PLAN COMMISSION STAFF REPORT

Tuesday, December 13, 2022 – 6:00 p.m.

Site and Landscaping Plans

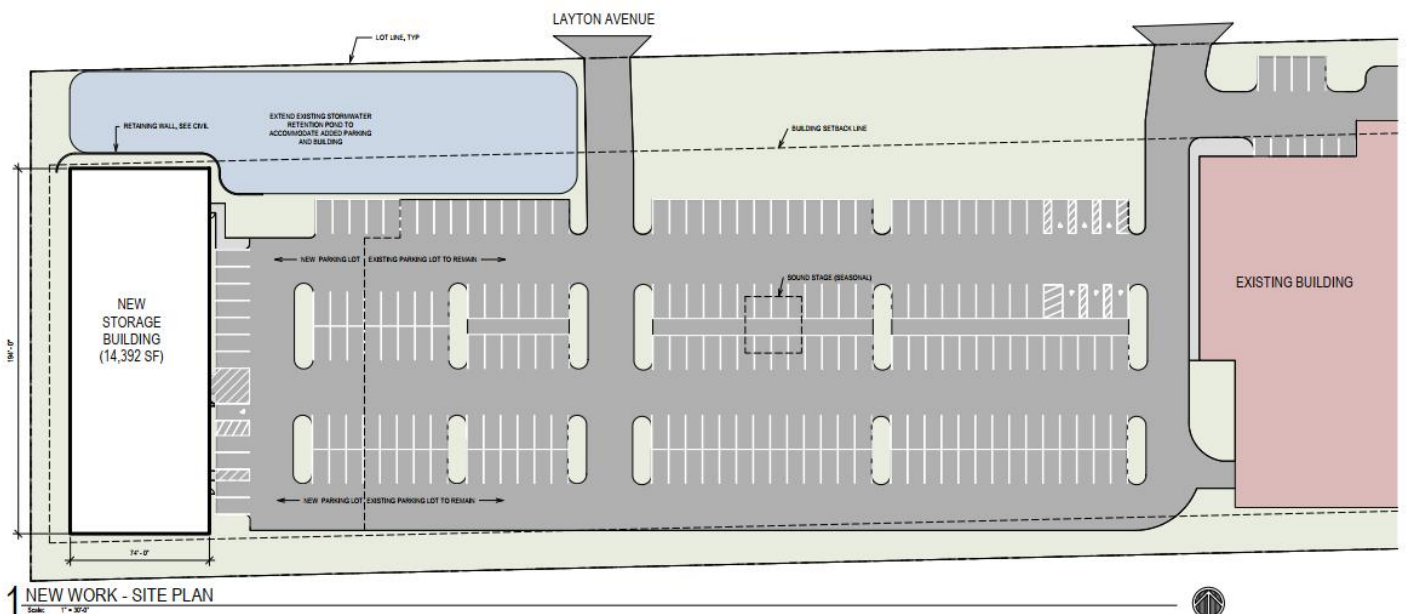
The 14,390 sq. ft. building will be constructed on the far west side of the newly-conjoined lot, creating a book-end look to the site with a parking lot in the middle. There are no new proposed curb cuts to W. Layton Ave.—the business will continue to utilize the existing

driveways. In fact, a curb cut will be closed on the 6417 W. Layton Ave. parcel. The existing parking lot will remain as is, and a small expansion of the parking lot will be continued west, towards the new building. The parking lot will be constructed with exterior and interior poured curb—there are no curb stops. There are 29 new proposed parking spaces.

Existing parking spaces = 182 (not including employee designated motorcycle parking)

Proposed development = removing 17 existing parking spaces, adding 44 new parking spaces = net 27 new additional parking spaces for a total of **209 provided** off-street parking spaces

PERSPECTIVE - FROM NORTH WEST

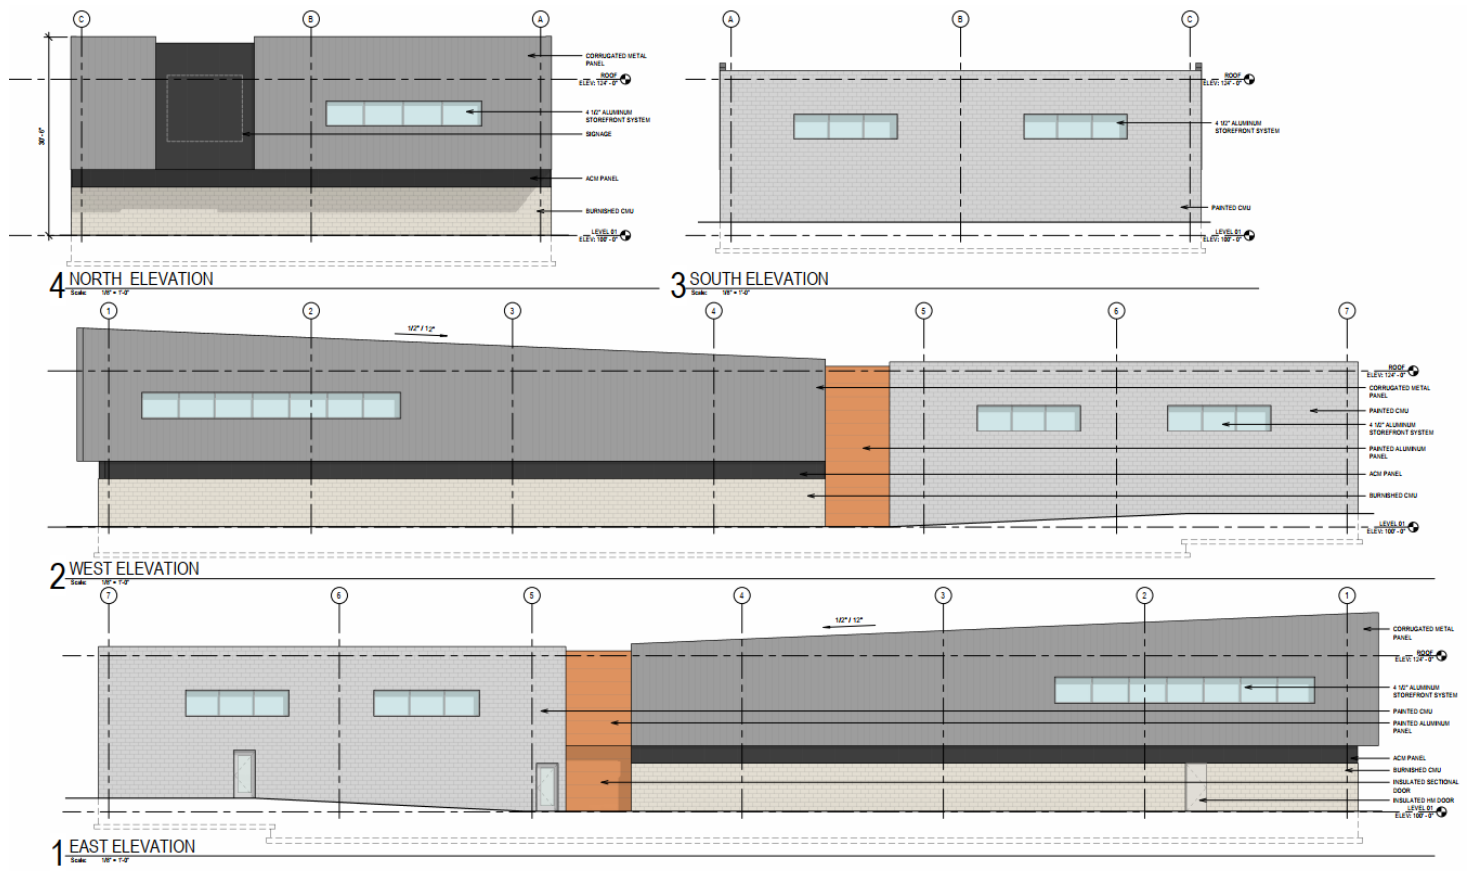
Given the enormity of this warehouse building and the fact that it is very visible from all sides (including from the 15-acre parcel to the south, which one day, the City expects will be developed), staff is recommending a few additional architectural relief features be added. There is a 65-ft. stretch of corrugated metal paneling that has no architectural relief. Staff is suggesting that some of the awning features, or similar design, from the existing dealership building be added in these larger areas of blank walls. Staff would also suggest that the rear 1/3 of the building include additional architectural relief, rather than constructing a plain 25-ft. tall painted CMU wall. Additional paint colors could be added to create a base, middle, top look, similar to the front. Again, the City anticipates future development to the south—that portion of the building will be visible from all sides. Another suggested architectural relief could be smaller metal awnings throughout the facades. Staff had also suggested using a different material for the middle orange section—using the fiber cement panel that has a cedar/wood look. This material has successfully been used at 84 South and at the Loomis Crossing development and it maintains the orange-ish color that HOH is looking to achieve.

1. Revised Site, Landscaping and Architectural Plans being submitted to the Community Development Division to show the following: (a) landscaping along the base of the building's west façade; (b) landscaping alterations at the request of the City Forester, if applicable; (c) architectural design modifications/relief, such as awnings, painting of a base/middle/top in the rear portion of the building, and Cedar/woodgrain fiber cement panels in the middle vertical section of the building, as recommended in the staff report; and, (d) a change in notation that the concrete base height for light poles within landscape islands be 6" in height.

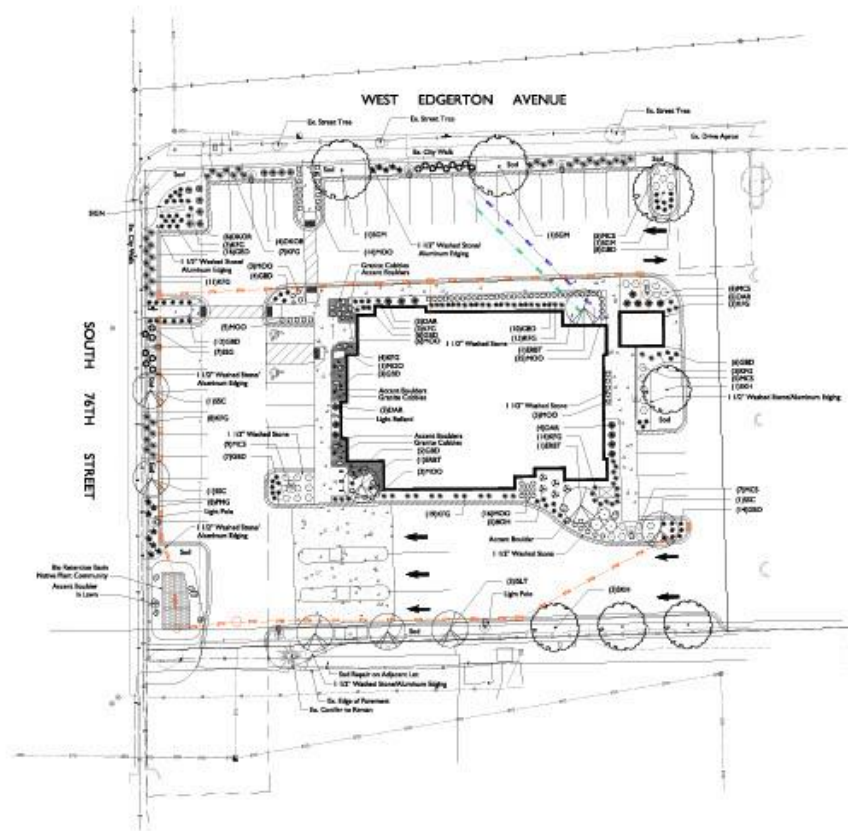
sidewalk located right next to the S. 76 St. roadway and no tree cover or foliage. Staff recommends additional broadleaf deciduous trees be added to the S. 76 St. planting strip. Staff also recommends an increase in shrubs vs. decorative grasses along S. 76 St. and W. Edgerton Ave. to help block headlight glare from entering the roadway. The landscape beds are proposed to be mulched with washed stone. Staff recommends wood mulch, rather than stone mulch. The bio retention basin in the southwestern corner of the property will contain native plantings.

1. Revised Site, Landscaping and Architectural Plan being submitted to the Community Development Division to show the following: (a) reduction in parking spot length to 19'; (b) landscaped bed along S. 76 St. increased by 2' in width with an increase in broadleaf deciduous trees and shrubs added to the beds; (c) landscaped bed along W. Edgerton Ave. increased by 1' in width with an increase in shrubs to the beds; (d) removal of washed stone mulch to be replaced with wood mulch; (e) reduction in height of concrete bases for light poles not to exceed 6"; and, (e) any landscaping specie/quantity recommendations as provided by the City Forester.

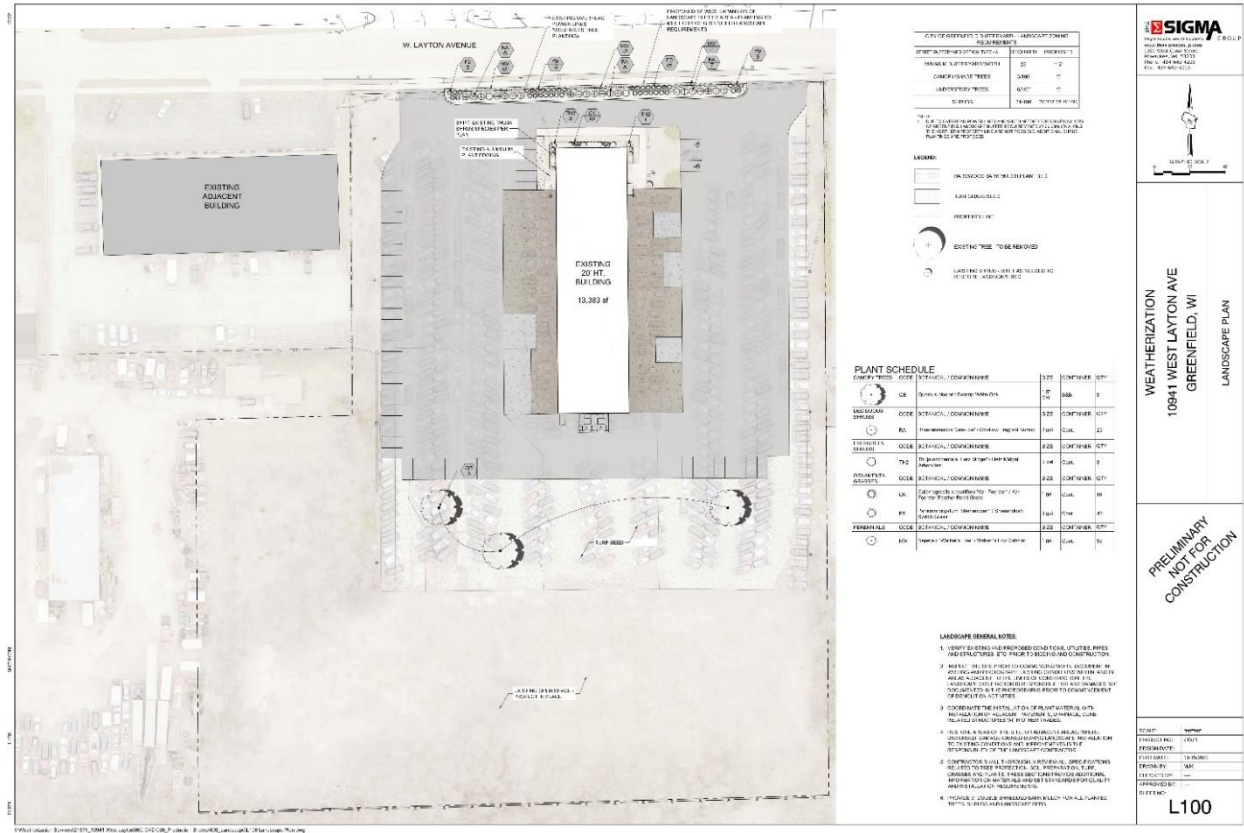
A site plan was submitted showing substantial improvements over the existing conditions onsite. The existing asphalt parking lot is in terrible shape. The applicant is proposing to remove the asphalt down to the base and repave. The existing gravel area behind the building will be paved in asphalt at this time. A large area of existing asphalt and gravel behind the building is not needed by the business and is proposed to be removed and restored to a lawn with landscaping. Additionally, an area of existing parking lot approximately 8' in width along the eastern property line will be removed and restored to a lawn. Portions of the concrete near the loading docks are also in terrible condition and will be sawcut and removed and replaced with new concrete. A deteriorated sidewalk along the western portion of the office will be removed and replaced in-kind. The smaller parking lot will have fifty (50) parking spaces. Fourteen (14) parking spaces are required per code. Per the Zoning Code, concrete curb meeting City specifications shall be required for all off-street parking areas serving more than five (5) vehicles in all nonresidential zoning districts," and staff recommends the addition of curb and gutter and submittal of a site grading plan for approval.

Additional site improvements include removal of dead trees along the eastern and western property lines, removal of a failed portion of the retaining wall along the west parking lot, removal of exposed steel and wooden boards from the retaining wall, removal of trash throughout the site, removal of a steel fence along the western rear parking lot, angling the light fixtures in the parking lot down to 90 degrees, and removal of noncompliant light fixtures on the building with no-cut light packs. A new concrete slab and board-on-board refuse enclosure are

1. Revised site, landscaping and architectural plans being submitted to the Community Development Division showing the following: (a) curb and gutter added around the parking lot and drive lanes; (b) site lighting plan and cut sheet of proposed lights; (c) a personnel door added to the refuse containers; (d) an increase in landscaping along the eastern parking lot/property line and rear lawn; (e) landscape bed along W. Layton Ave. being reconfigured to not be placed over existing manholes; and, (f) any landscaping specie/quantity recommendations as provided by the City Forester.

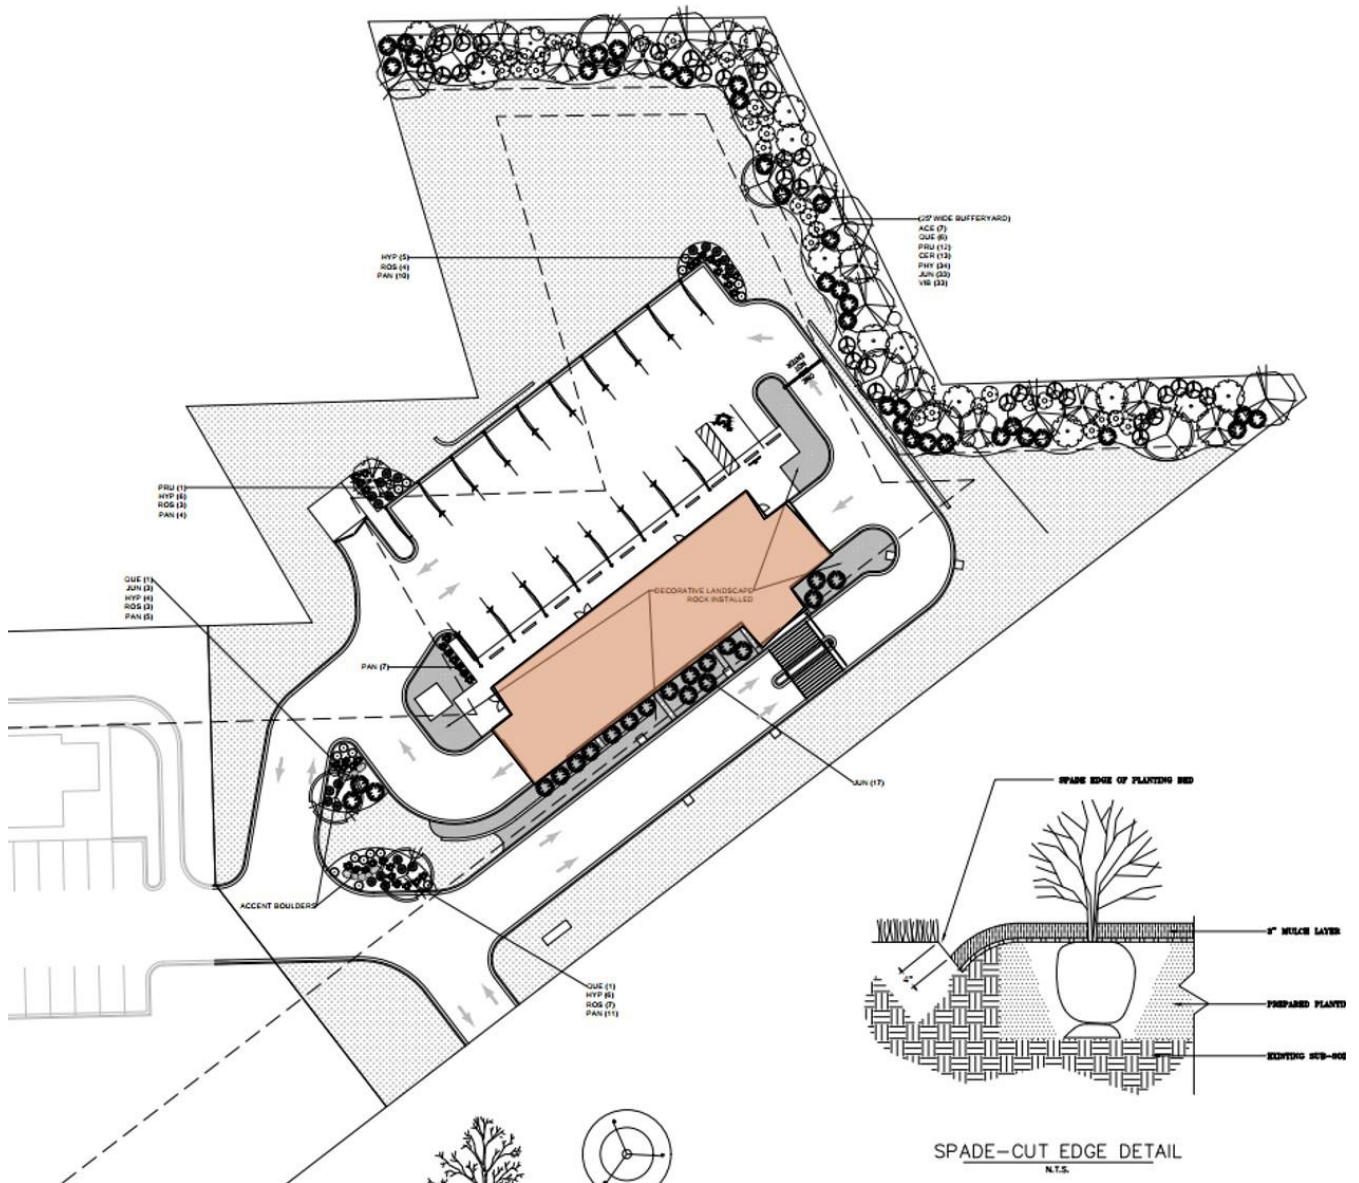
The commercial business to the north, A&A Tire, has parking stalls in the rear of their site that encroach onto the Genesis property. There is no notation on the plan how the applicant plans to address the encroachment or if there is a current easement in place. The plan identifies a few new retaining walls, but no material or elevations have been provided for them. The plan identifies a canopy over a portion of the queuing lane, likely to shelter the users as they select their car wash type and pay. The proposed canopy is encroaching within the 50-ft. setback requirement and an architectural rendering/elevation has not been supplied for the canopy. A four-sided refuse enclosure with personnel door is shown on the building elevation plans (proposed to be constructed of CMU block), but is not identified on the site plan.

The landscaping plan identifies a 25-ft. wide landscaping buffer along the northeast property line abutting the single-family residential properties and some basic perimeter landscaping along the south side of the building. The plans show stone/rock mulch in the landscape beds around the building, which the City's Forester strongly opposes. The proposal includes four (4) large landscape bed areas along the base of the building that are entirely stone/rock, no landscaping. Per Section 21.06.0304.I. of the Municipal Code, General landscaping requirements, "Foundation landscape plantings required along front building facade in all nonresidential districts. A minimum foundation landscape planting area of five (5) feet in width shall be required in the C-1, C-2, C-3, C-4, C-5, O, BP, M-1, I, PR, and PUD Districts." The landscaping plan does not include landscaping (other than grass) within the 25-ft. wide area between the W. Beloit Rd. property line and the queuing/stacking drive. Per Section 21.06.0305A.3. of the Municipal Code – General bufferyard requirements, "Peripheral bufferyards shall be along the outer perimeter of a lot or parcel, and shall extend to the lot or parcel boundary line. Peripheral bufferyards shall not be on any portion of an existing or dedicated public or private street or right-of-way." Staff is recommending that substantial landscaping for the purposes of screening the queuing line, be installed along the entire length of the W. Beloit Rd. property line.

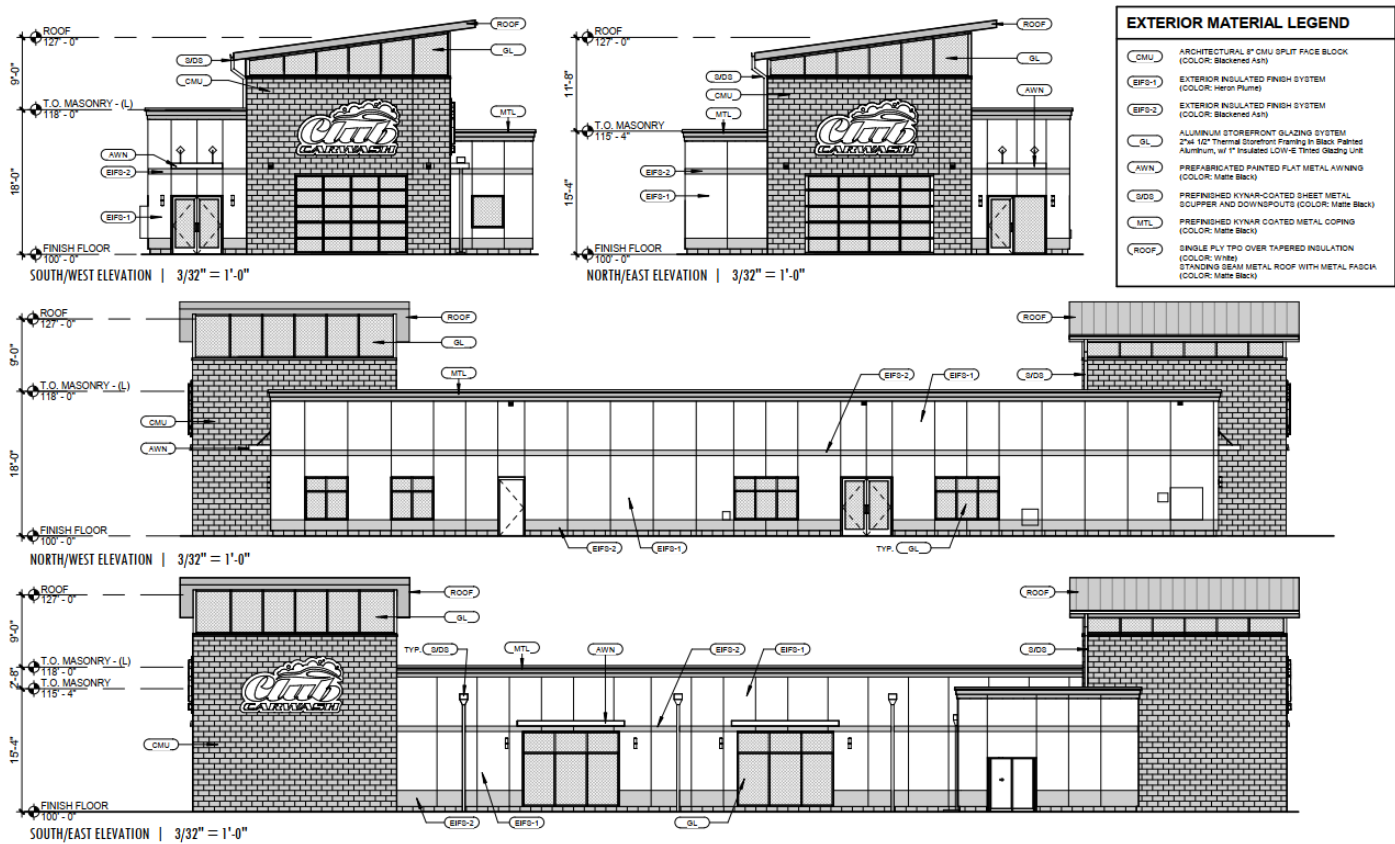
For the pre-submittal meeting that staff had with the designers, a draft building rendering was supplied showing an all-block car wash building. Based on design of the City's most-recently-approved car washes, staff recommended that a stone or brick material be incorporated into the building, perhaps, at a minimum, where the dark gray towers are located. The official submittal identifies the dark gray towers being constructed with 8" CMU split face block with an aluminum storefront glazing system decorative peak above. The 136-ft.-long walls are proposed to be constructed with EIFS from the ground level to the top (with one course of CMU block at the ground level), a completely-different proposal than what was provided at the pre-submittal meeting, with lesser-quality materials. Per the City's Site Development Standards, EIFS-type of materials is an inappropriate façade material below the top of door openings. Neither the Tsunami Car Wash on W. Layton Ave. nor the Mister Car Wash that is going on S. 27 St. have EIFS materials on their buildings. Staff would hold this proposal to the same standards, as was communicated during the pre-submittal meeting. All four (4) elevations include various aluminum storefront glazing system window openings or door openings to provide some architectural relief. The roof is proposed to utilize standing seam metal material with a metal fascia, colored in black. There are a few prefabricated painted metal awnings throughout the façade as well.

Staff is recommending denial of the proposal based on the site layout and scale of the building and its accommodating uses in proximity to neighboring uses (single-family properties) immediately to the east, and the potential impacts upon neighboring uses, along with the multiple site, landscaping and architectural elements that do not meet the Municipal Code's
